**Illinois Tollway Base Sheet Revisions**

Section M		Base Sheet Drawings	
Drawing	Modification Summary	Effective: 03-01-2026	
<b>Plaza Electrical Work (Business System)-Series 2500</b>			
<b>M-BUS-2503</b>	<b>Single Line Power Diagram</b>

VERSION: 2026-03      BASE SHEET: M-BUS-2521      SHEET: 1 OF 1

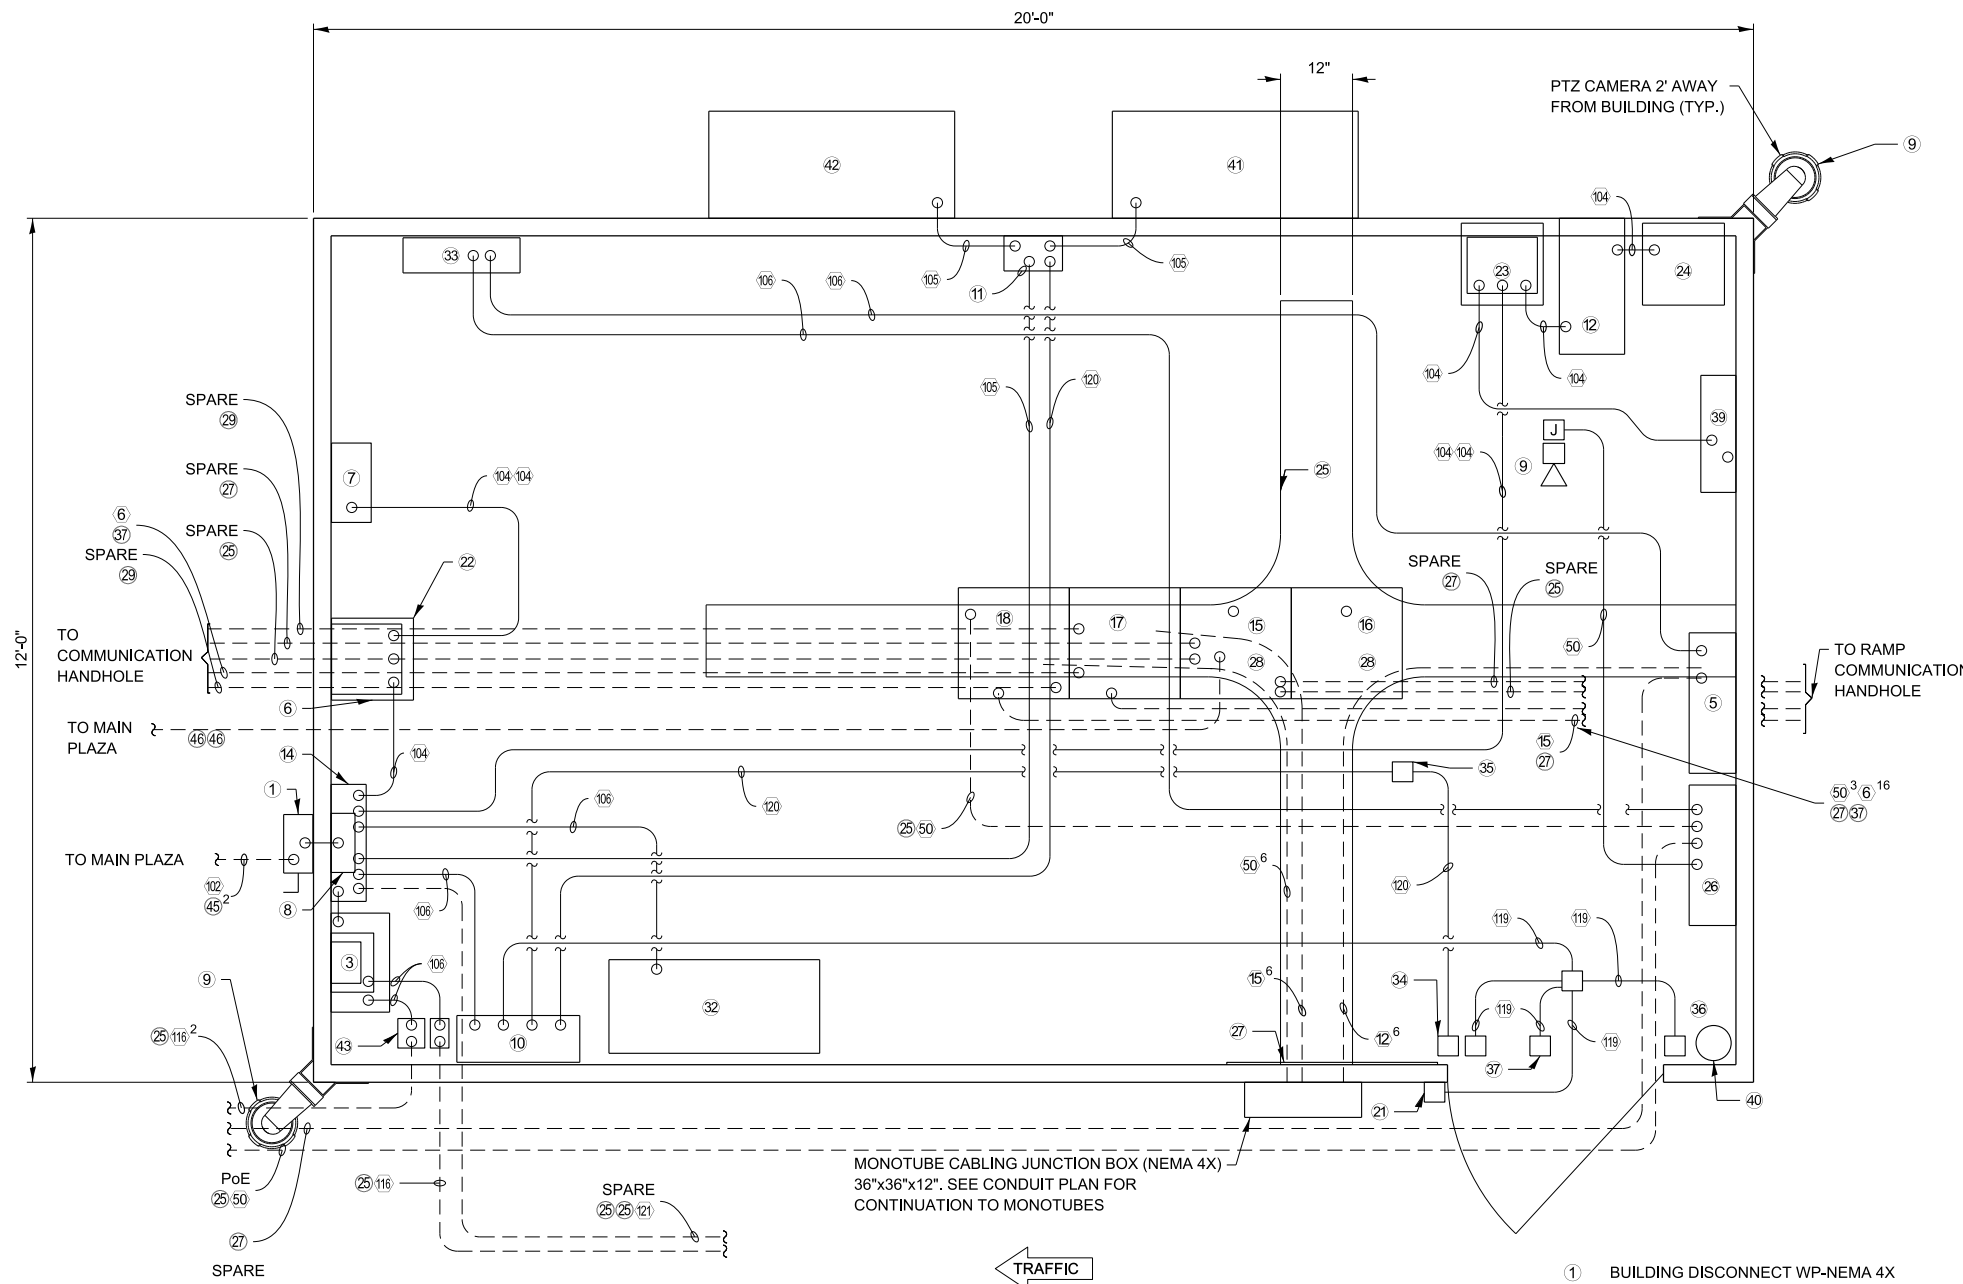
Sheet 1	Added call out for 1 1/2" HDPE SDR-11 VES Was Tubing		
<b>M-BUS-2521</b>	<b>Control Building Equipment Layout - Remote Plaza</b>		
Sheet 1	Item 22: changed designation to Free Standing UPS (4KVA)

Item 31: air compressor removed		
	Item 23: changed designation to Not Used		
<b>M-BUS-2522</b>	<b>Interior Elevations - Remote Plaza</b>		
Sheet 1	Changed description for Item 22 to say: Free Standing UPS (4KVA)		
<b>M-BUS-2526</b>	<b>Panelboard Schedules - Remote Plaza AET Lanes</b>

VERSION: 2021-03      BASE SHEET: M-BUS-2525      SHEET: 1 OF 1

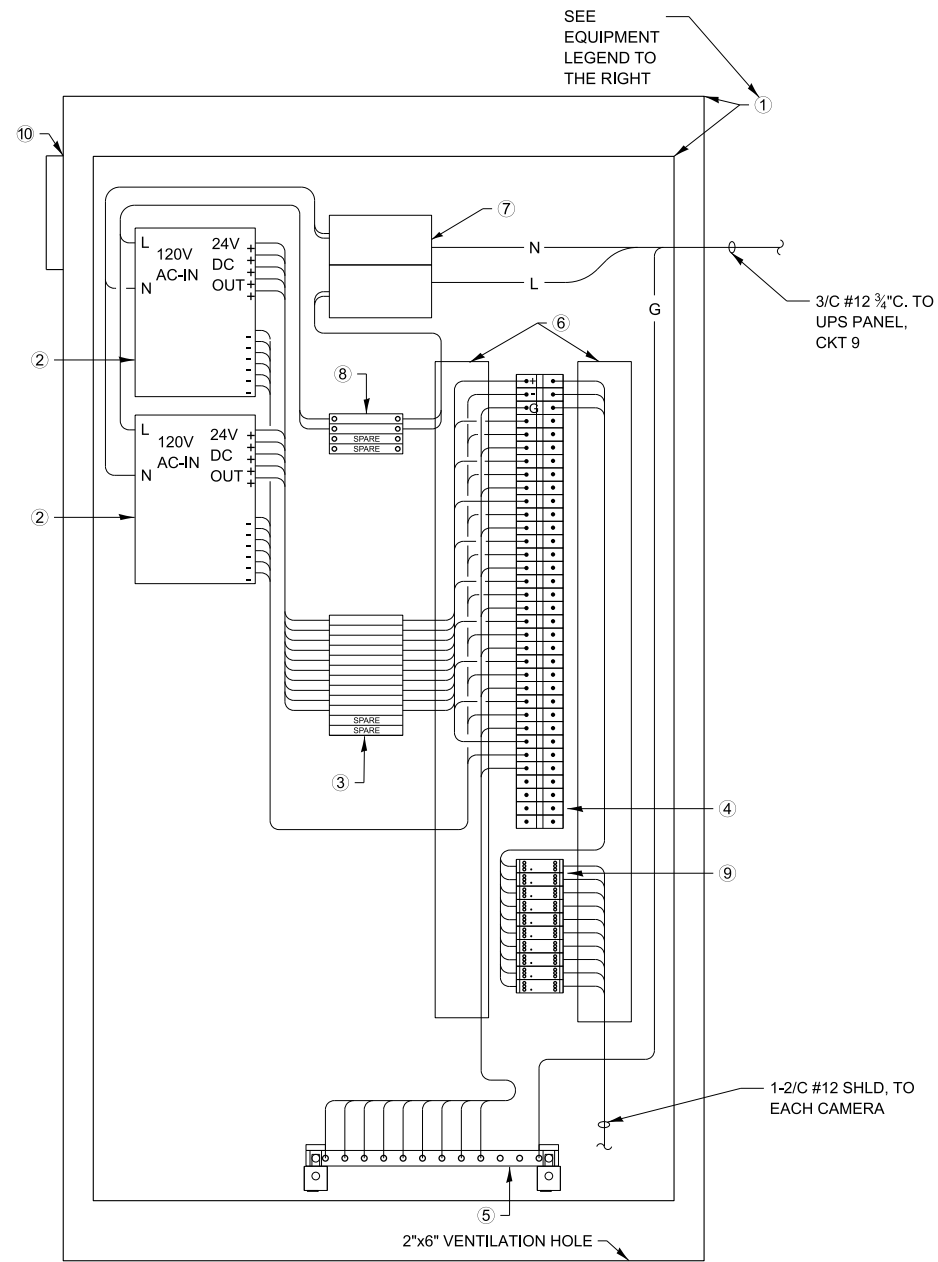
Sheet 1	Separated HVAC 1 and HVAC 2 with their respective loads for Phase A, Phase B and Phase C with 50A/2P breaker for each HVAC unit		
	Updated the total load for Phase A, Phase B and Phase C		
	Replaced spare breaker 30A/2 to 50A/2P		
	Updated subtotal power values for Phase A, Phase B and Phase C		
	Updated total load (Watts) for Phase A, Phase B and Phase C		
	For UPS-2 (Tolling and ITS) updated load to 2500w for Phase A and Phase C

**VIDEO POWER JUNCTION BOX  
DETAIL - REMOTE PLAZA**

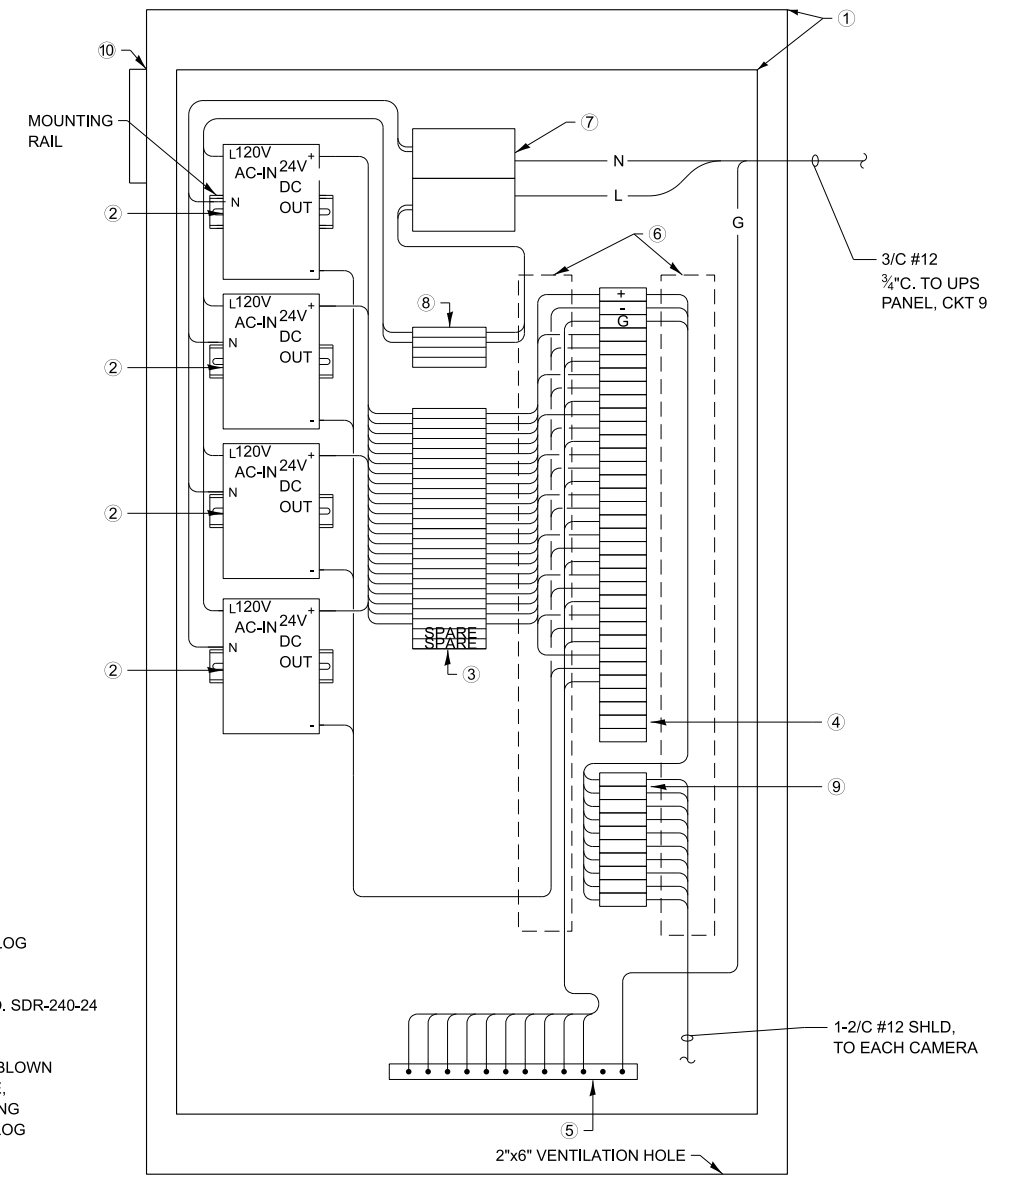
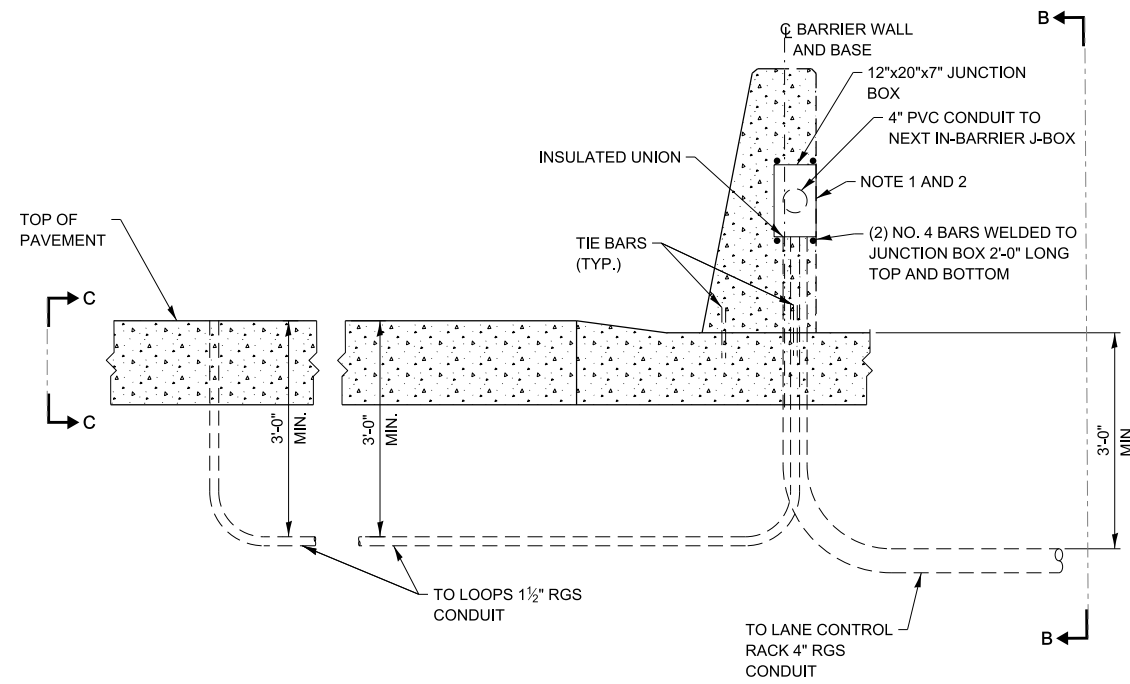
Sheet 1	Revised Item 1 enclosure model number: use Hoffman model # A-482408LE with white panel		
<b>M-BUS-2529</b>	<b>UPS Single Line and Wiring Diagram</b>

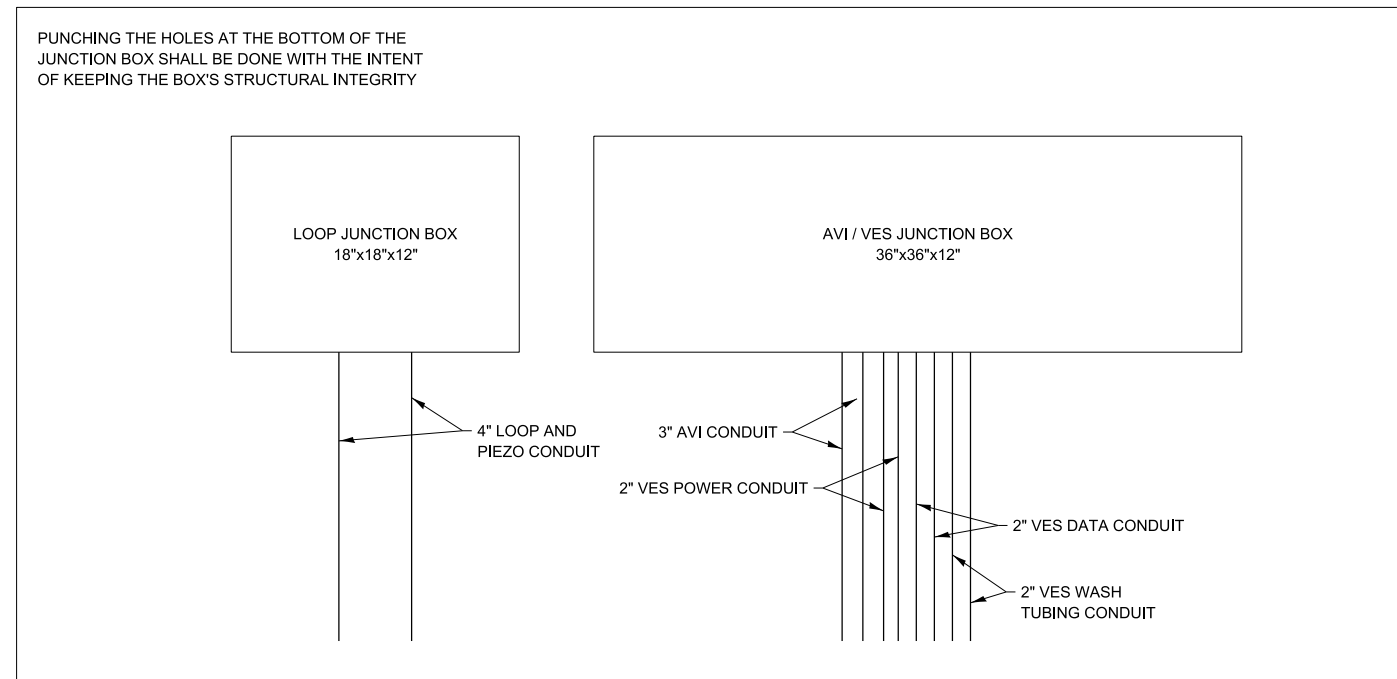
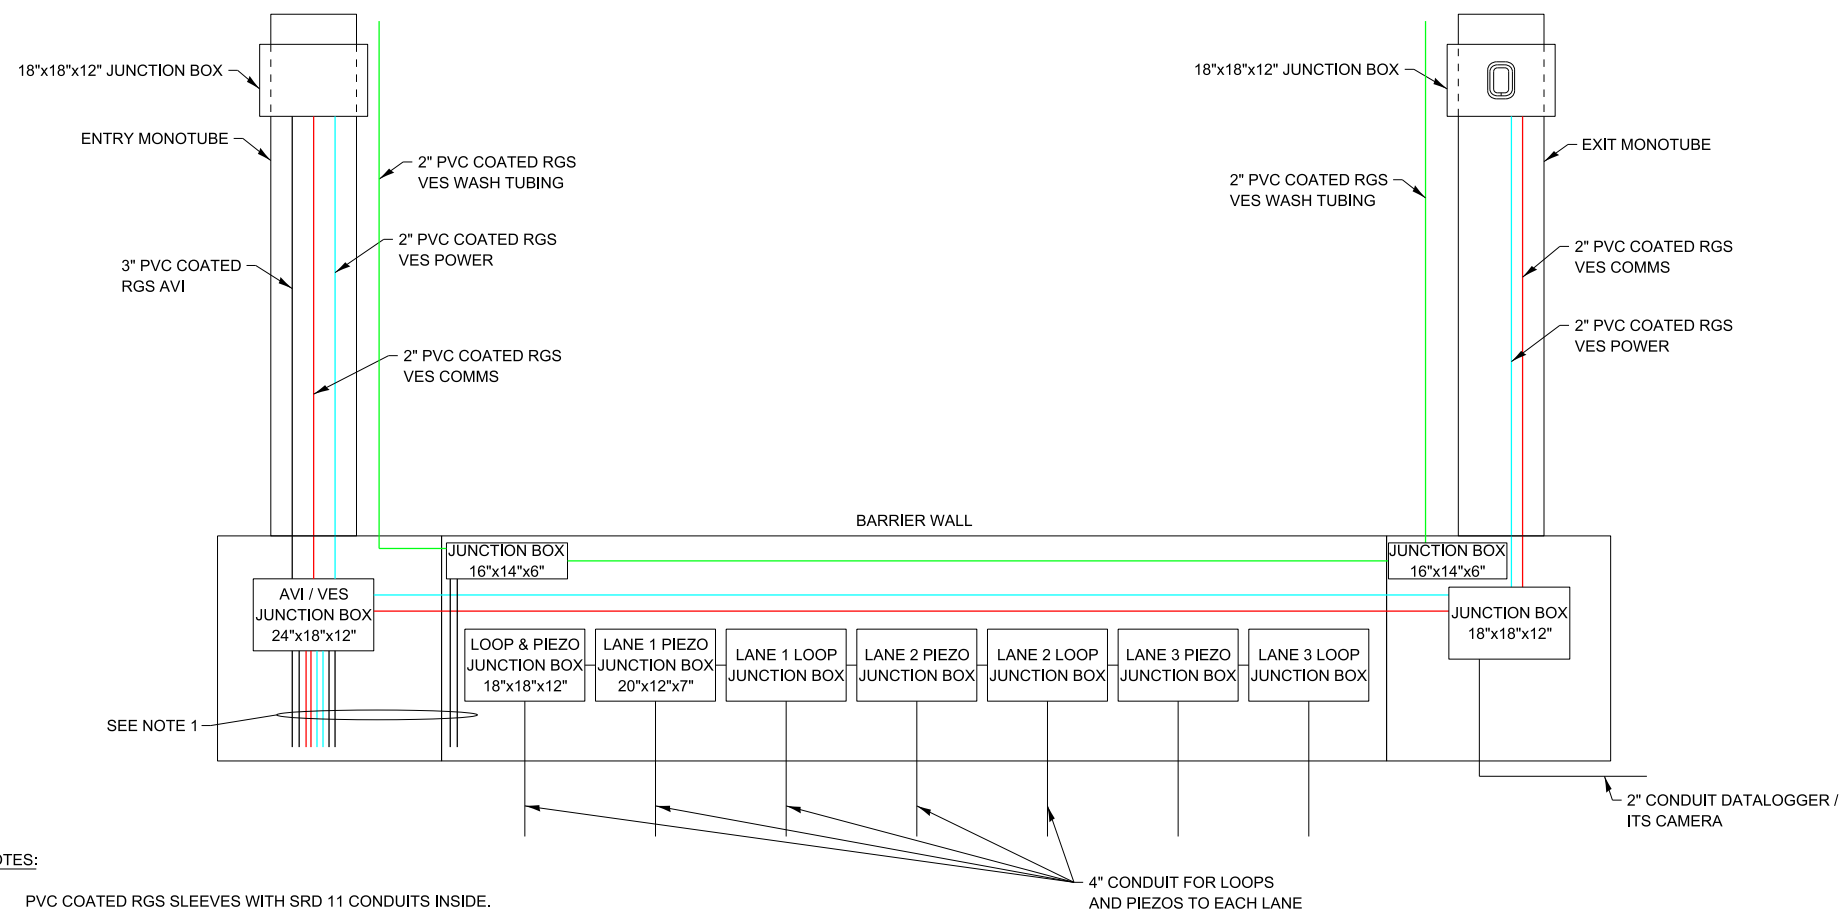
Sheet 1	Lane loop junction box, conduits attached to barrier wall from approach monotube to departure monotube		
	Show conduits routing for VES cameras power and data, VES wash tubing		
	Show junction boxes for AVI/VES conduits, show junction boxes attached to monotubes		
<b>M-BUS-2536F</b>	<b>Duct Spacer Details</b>

VERSION: 2026-03	BASE SHEET: M-BUS-2539	SHEET: 1 OF 1
---------------------	---------------------------	------------------

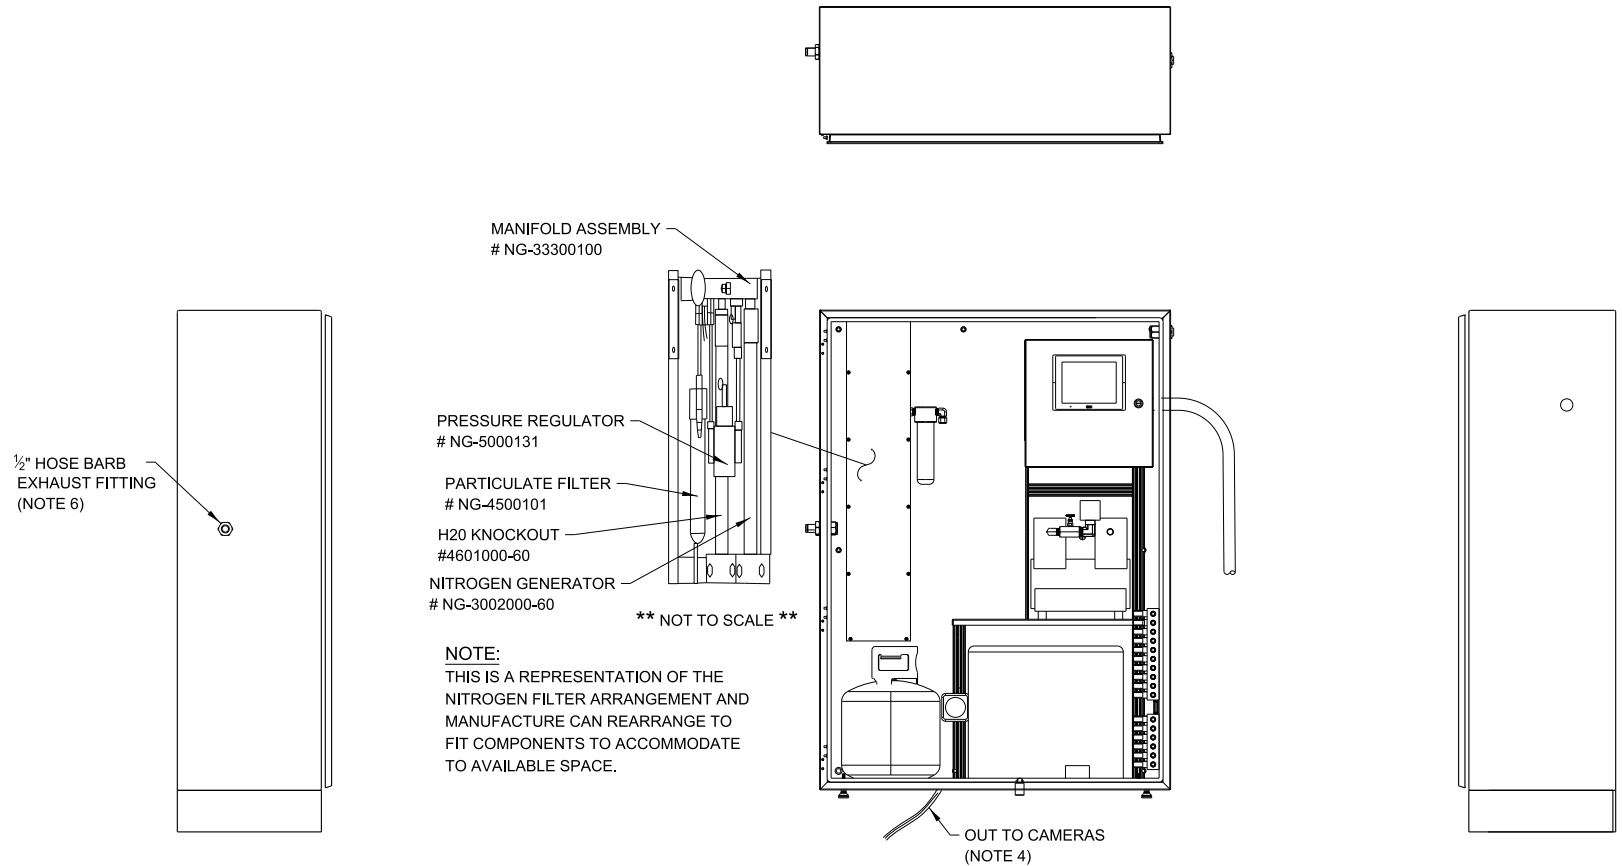
Sheet 1	Added sentence to Note 4: Contractor shall keep a 1 foot slack inside the VES wash enclosure for each of the VES Wash tubing when connected to the solenoid distribution		
	Revised Note 9 to replace the word Optional by a 500 Watt heater
